## SERVICE LETTER No. L 148-Rev.1

### MAINTENANCE ALERT

**MODELS AFFECTED:** Z 242 L aircraft, S/N 0681, 0682, 0684, 0685, 0699, 0727, 0739, 0742, 0743, 0744, 0745, 0746, 0848, 0849.  
Note: the instructions below for other Z 242 L aircraft will be issued by Information Service Bulletin Z242L/47b.

**SUBJECT:** IN-SERVICE SAFETY EVENT REPORTING

Fig. No. 1

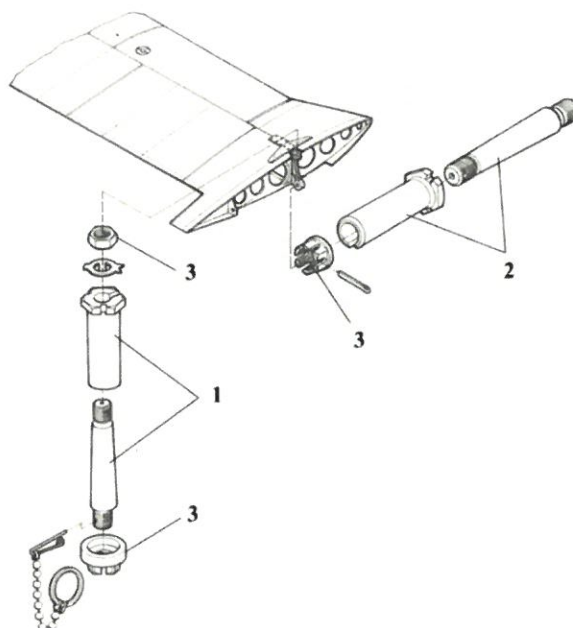
1. The basic technical lifetime of pins of the main hinge of the wing of the aforementioned aircraft is set to **1500 flight hours** or **200 flights hours** in AEROBATIC category. (whichever comes first and/or if a shorter time is not determined by the evaluation of the data from the AMU 1 accelerometer).

*In case of removing the vertical pin, drawing number Z42.2181 (Ø20 h6), and/or horizontal pin, drawing number Z42.2191-00.00 (Ø20 h6) – see Picture 1) for any reason, it is necessary to always install completely new pins of the same dimension.*

*Re-use of the originally installed pins after their removal is forbidden and they always need to be taken out from operation, which must be properly documented.*

For tightening nuts M10 – see Picture 1, item 3, a torque wrench must be used at all times to meet the requirements of the prescribed tightening torque (23-27 Nm – see Maintenance Manual part 2, chapter 7.5).

**Tightening of nuts without using the torque wrench is forbidden.**

Always use only tools prescribed by the manufacturer for pin removal (drawer L242.9510-00.00).

**It is forbidden to use tools not approved by the manufacturer for pin removal.**
